ADDENDUM 3

6/4/2025
Capstone at Convington Place
24-064

The Banyan Foundation

1 ELECTRICAL SITE PLAN
1" = 30'-0"

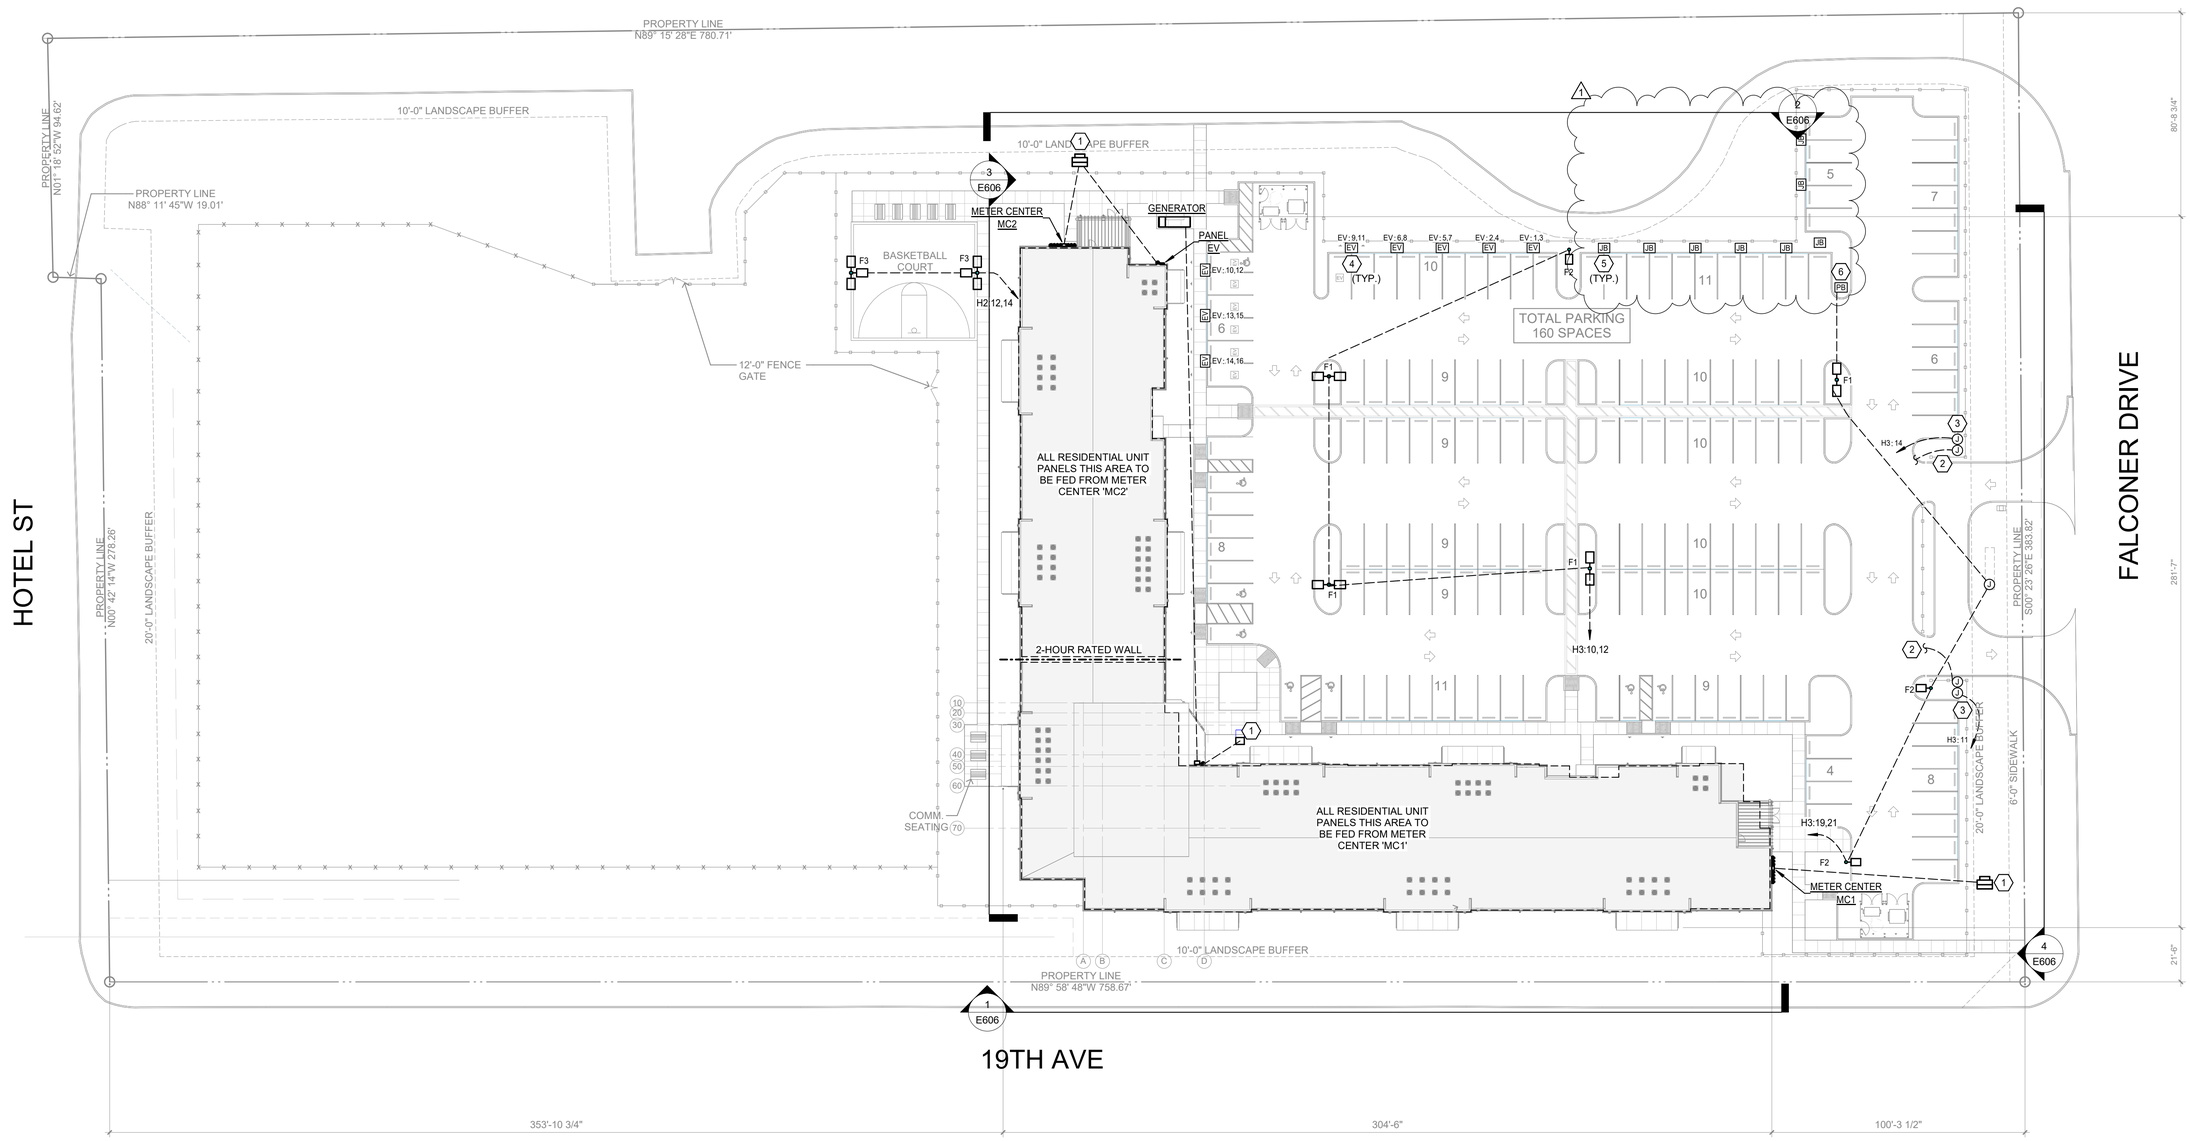
Add 1.75 **E100 – Electrical Site Plan**
- Note changes to 1E100.

1 1ST FLOOR ELECTRICAL PLAN - AREA 1
3/32" = 1'-0"

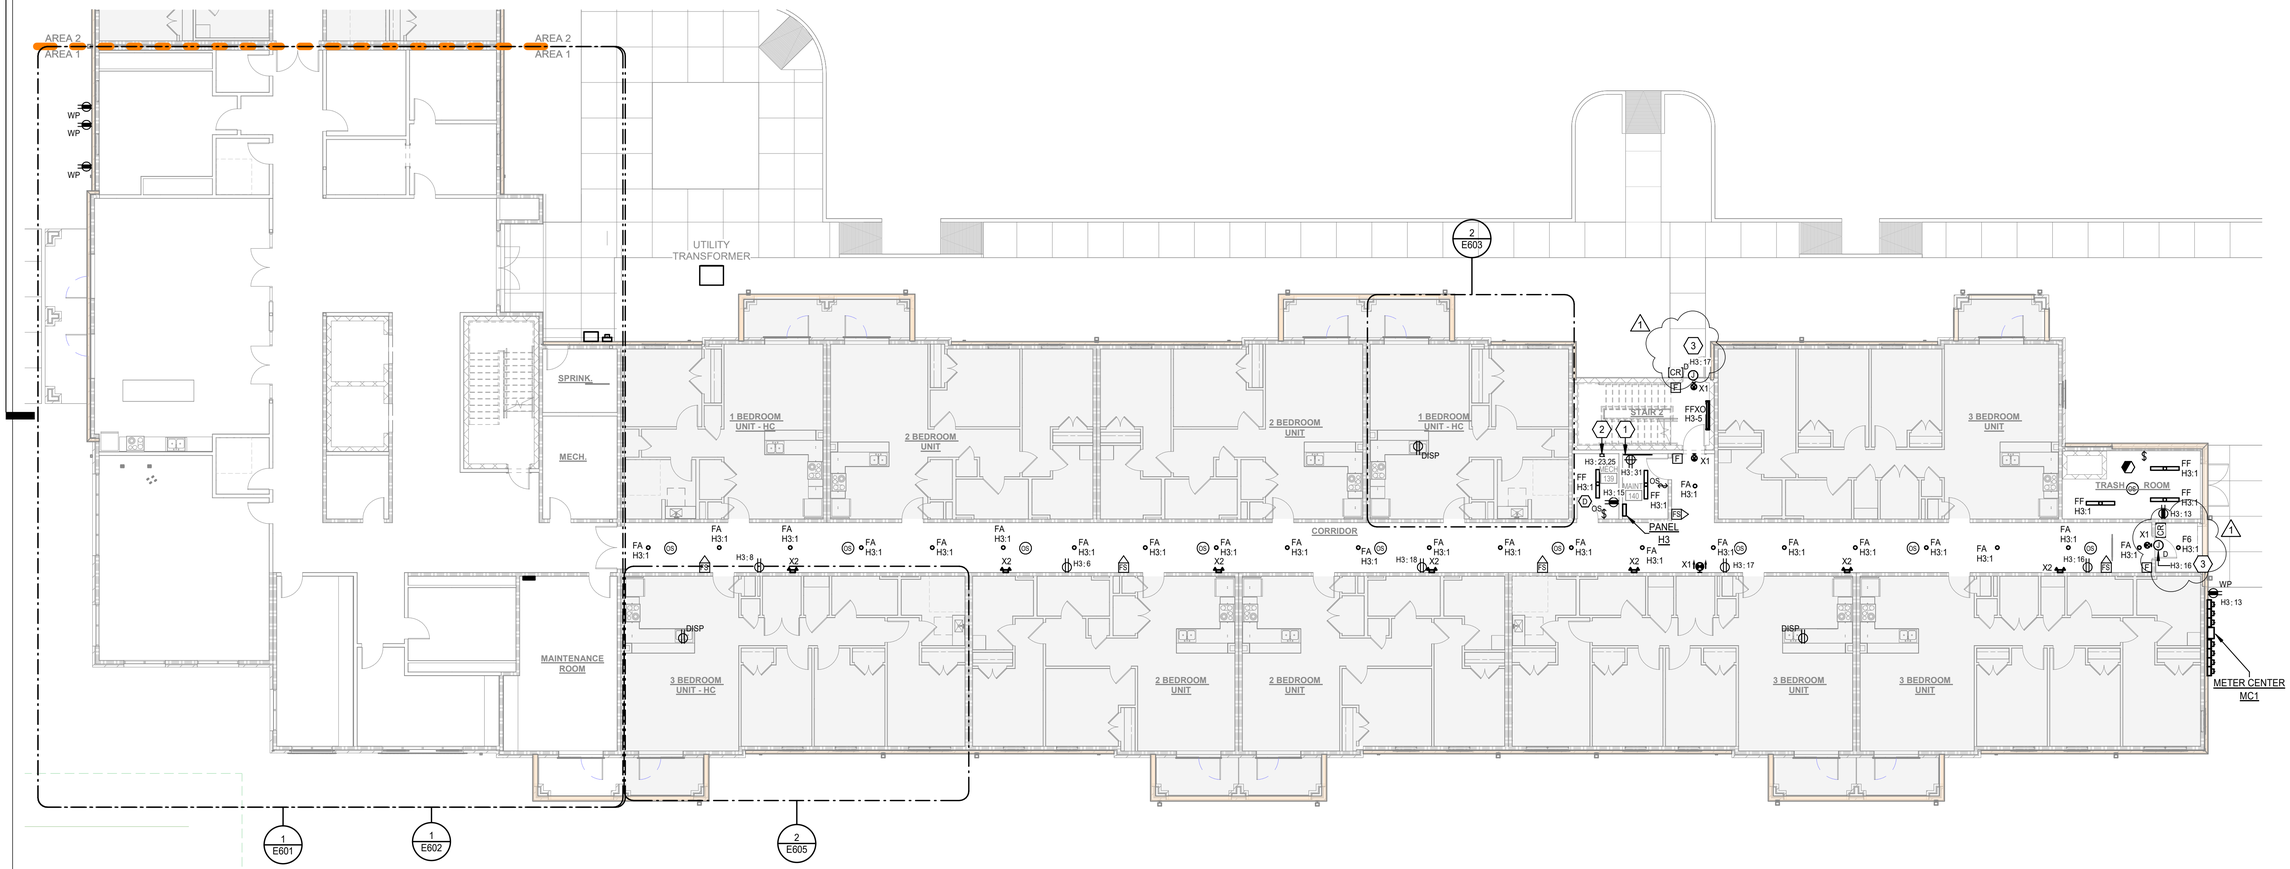
Add 1.76 **E101 – 1st Floor Electrical Plan – Area 1**
- Note changes to 1E101.

1 1ST FLOOR ELECTRICAL PLAN - AREA 2
3/32" = 1'-0"

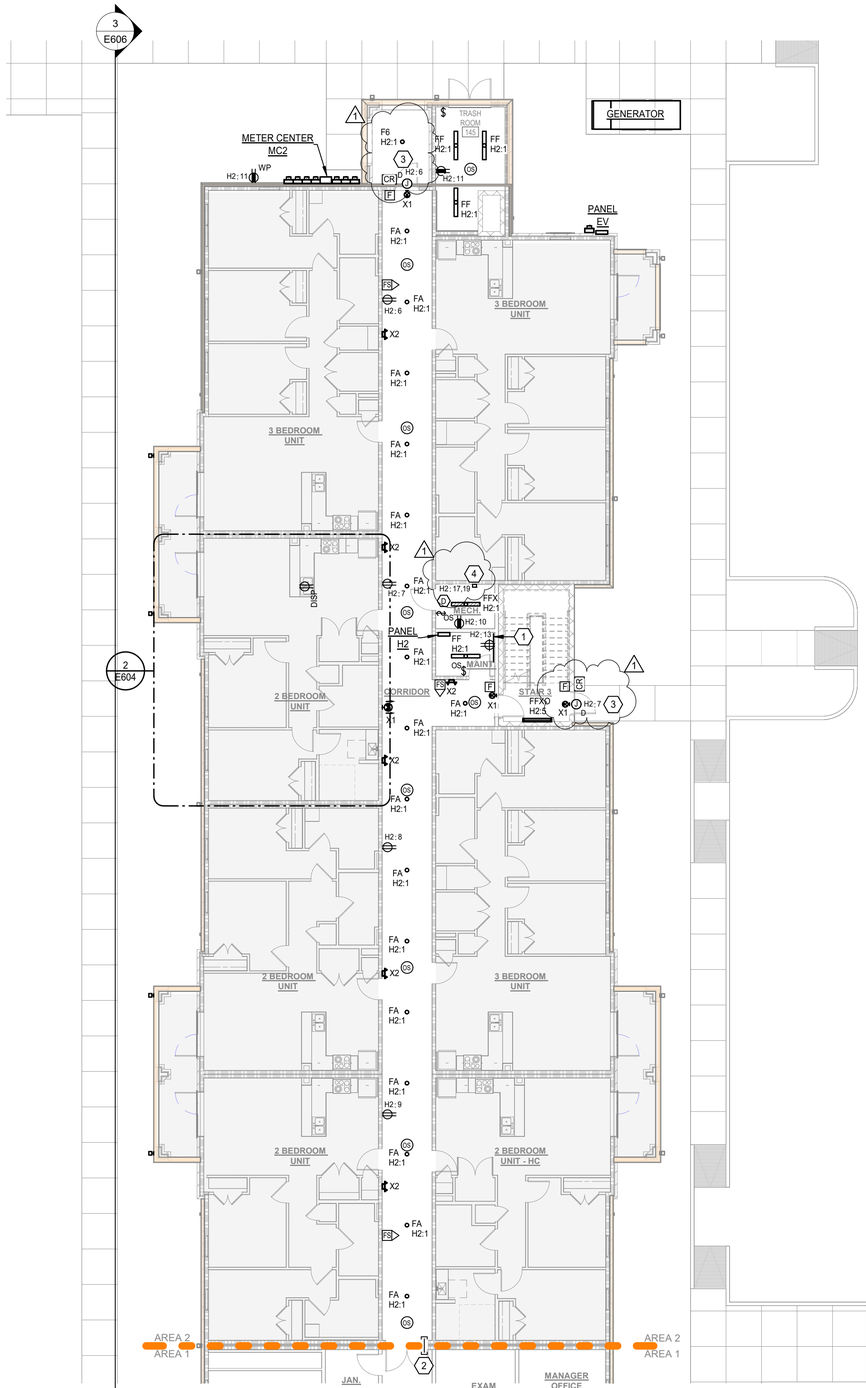
Add 1.77 **E102 – 1st Floor Electrical Plan – Area 2**
- Note changes to 1E102.

1 2ND FLOOR ELECTRICAL PLAN - AREA 1
3/32" = 1'-0"

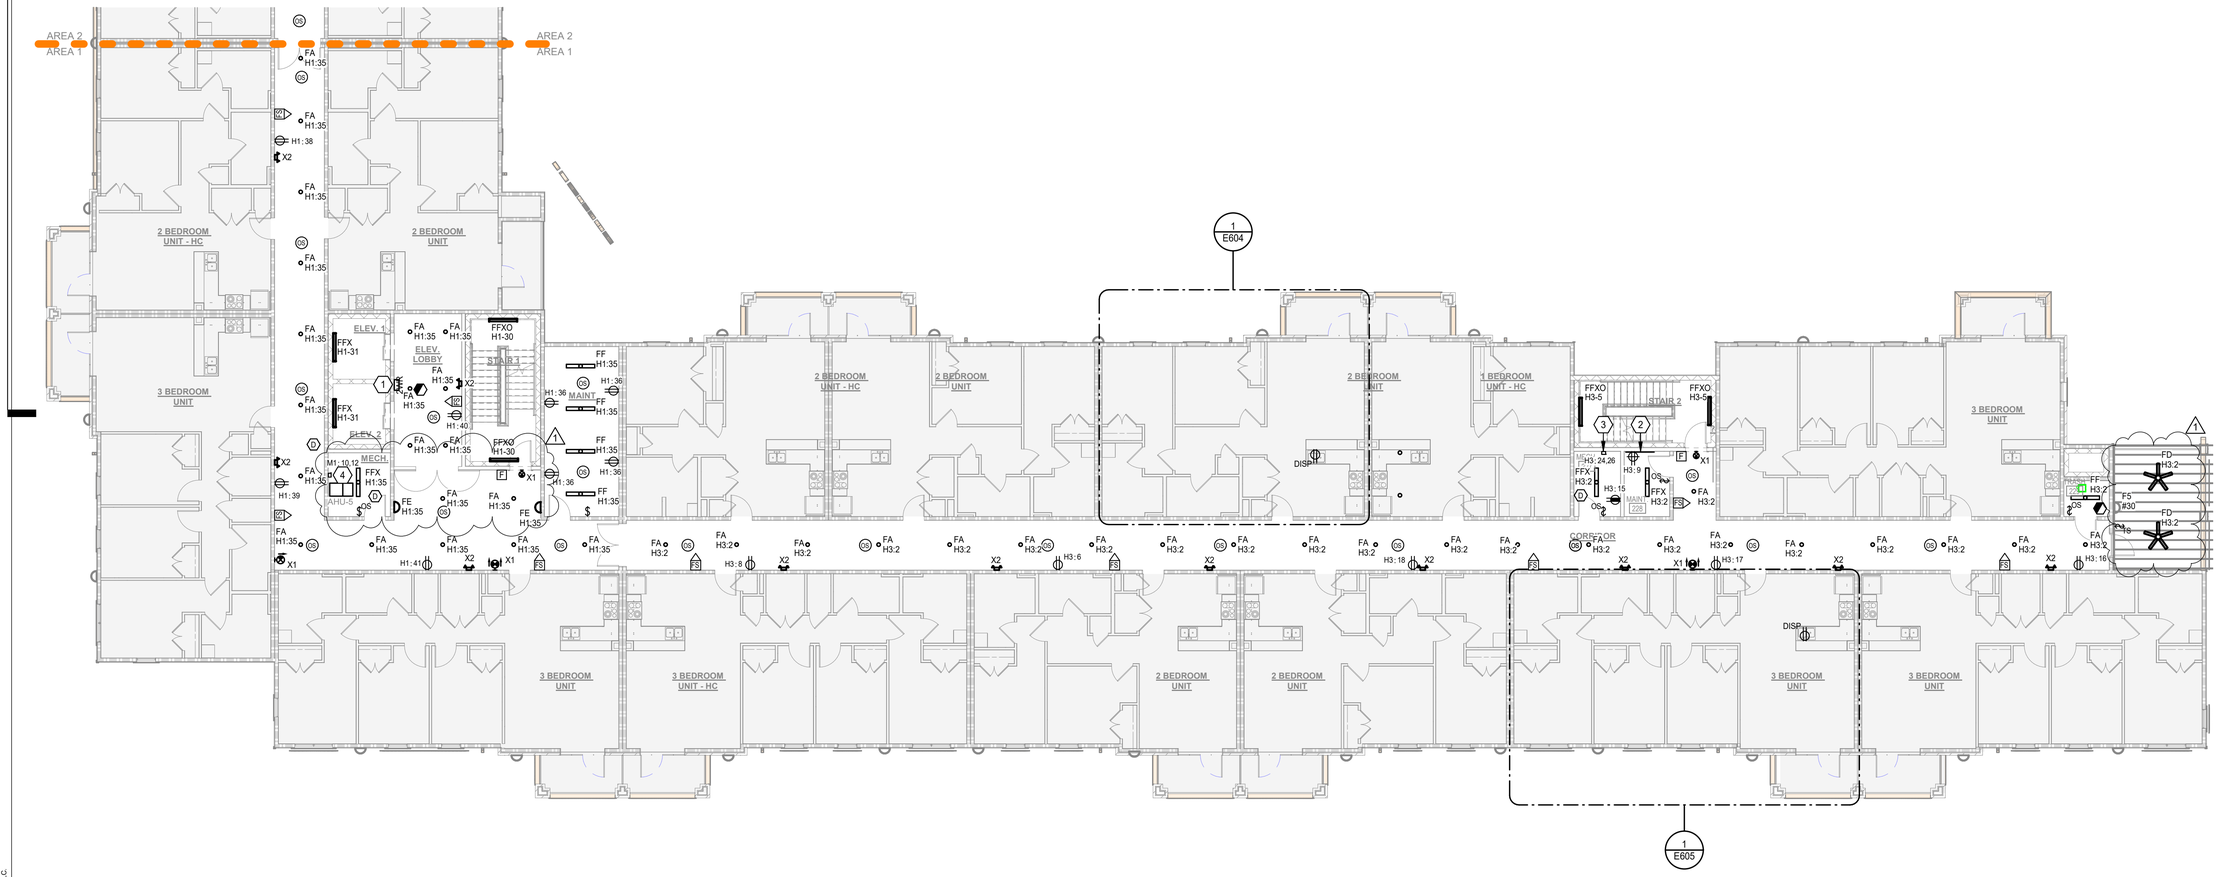
Add 1.78 **E201 – 2nd Floor Electrical Plan – Area 1**
- Note changes to 1E201.

1 2ND FLOOR ELECTRICAL PLAN - AREA 2
3/32" = 1'-0"

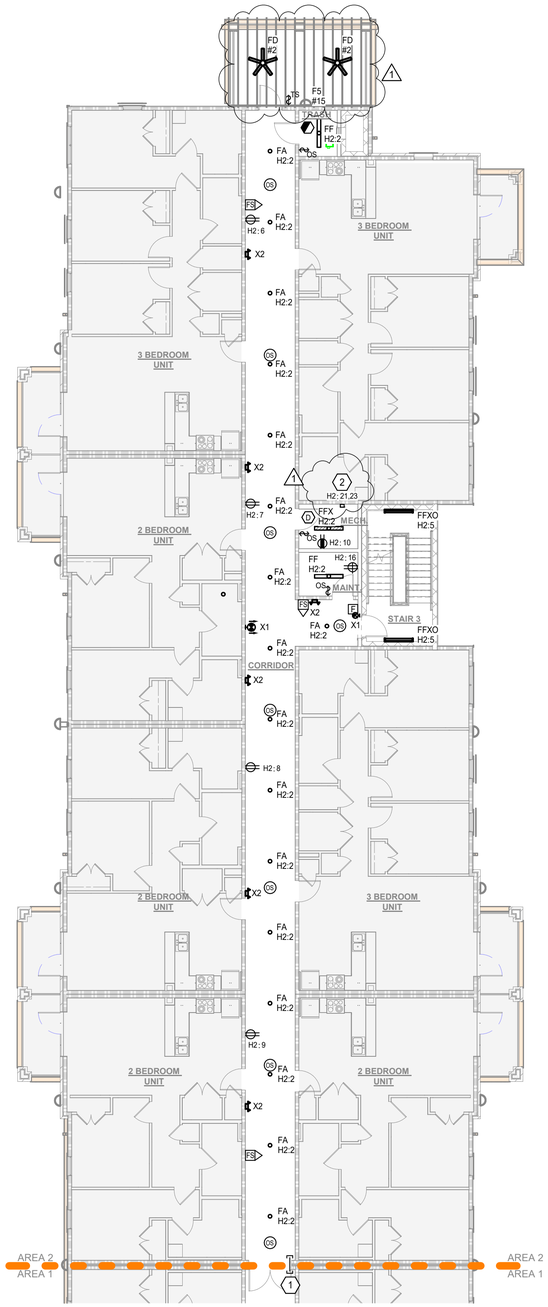
Add 1.79 **E202 – 2nd Floor Electrical Plan – Area 2**
- Note changes to 1E202.

1 3RD FLOOR ELECTRICAL PLAN - AREA 1
3/32" = 1'-0"

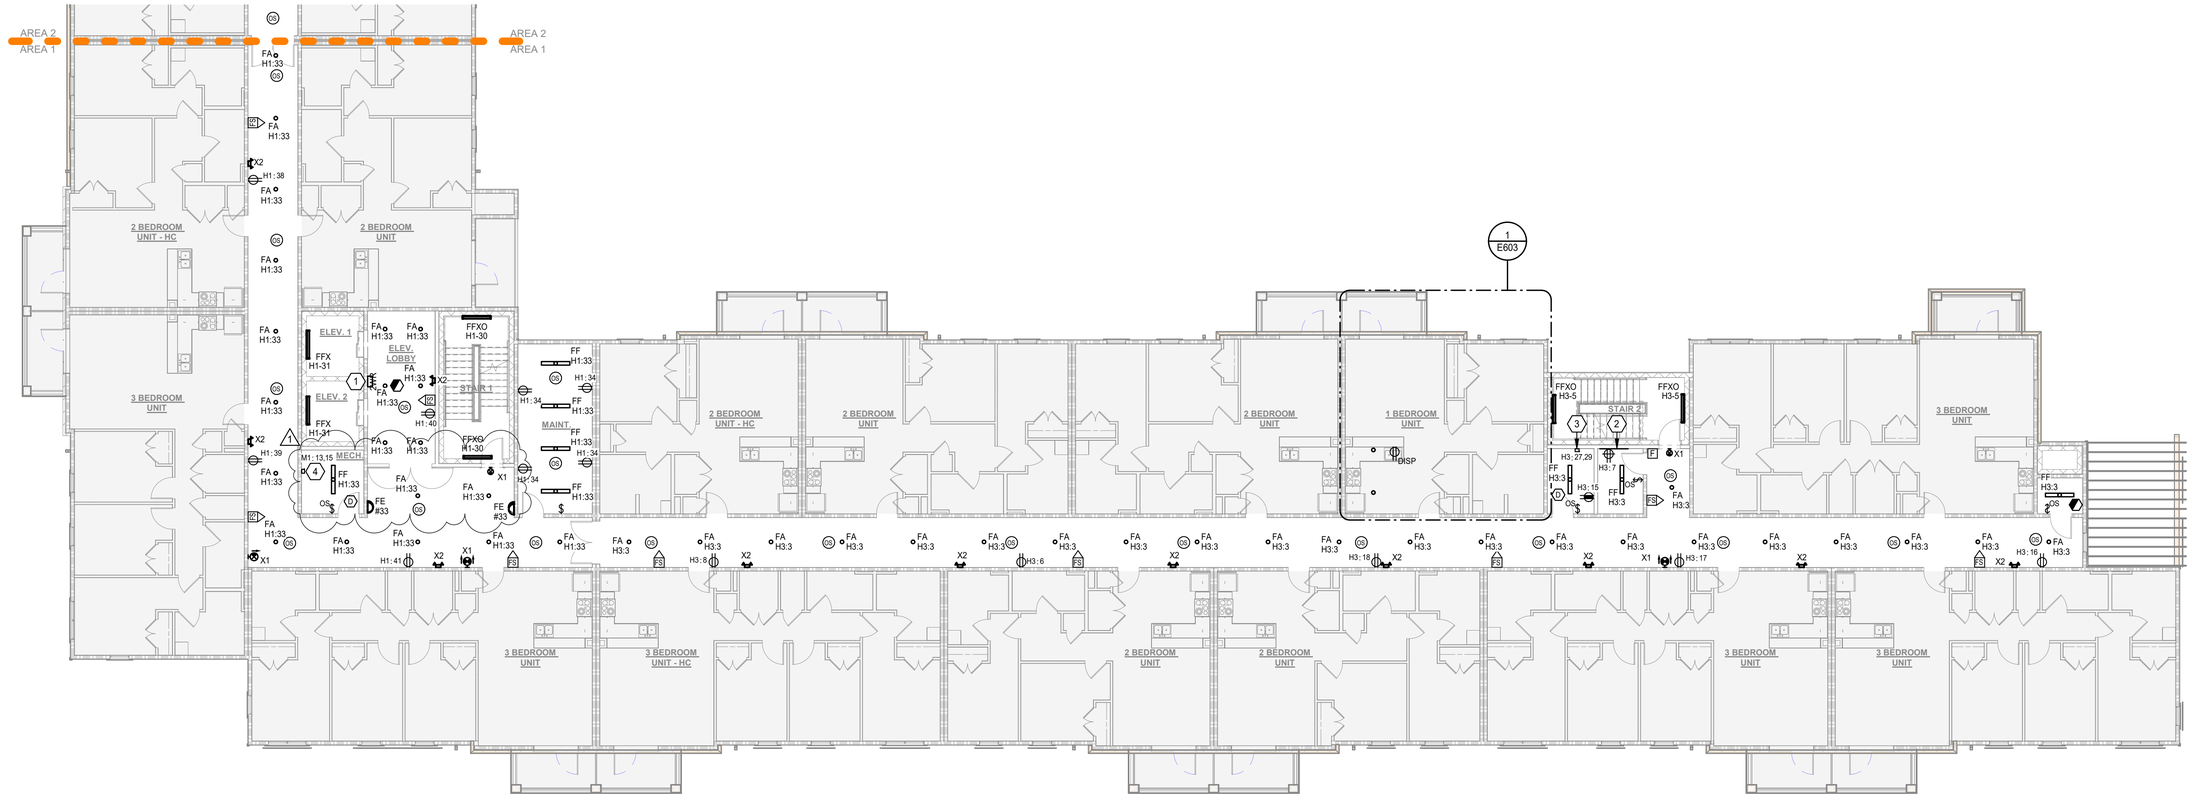
Add 1.80 **E301 – 3rd Floor Electrical Plan – Area 1**
- Note changes to 1E301.

1 3RD FLOOR ELECTRICAL PLAN - AREA 2
3/32" = 1'-0"

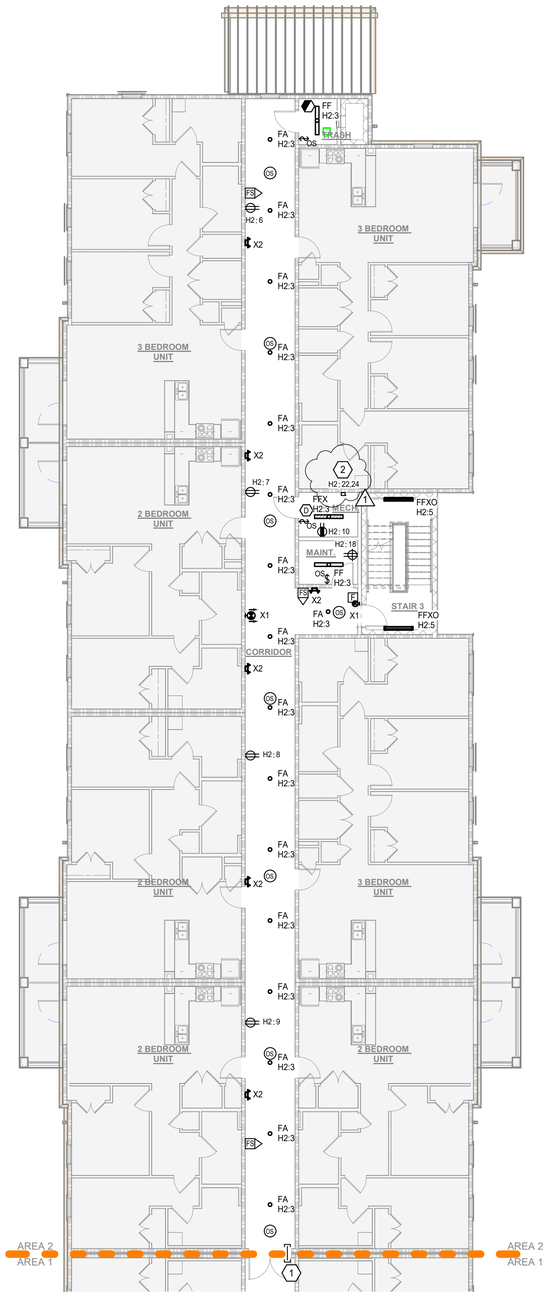
Add 1.81 **E302 – 3rd Floor Electrical Plan – Area 2**
- Note changes to 1E302.
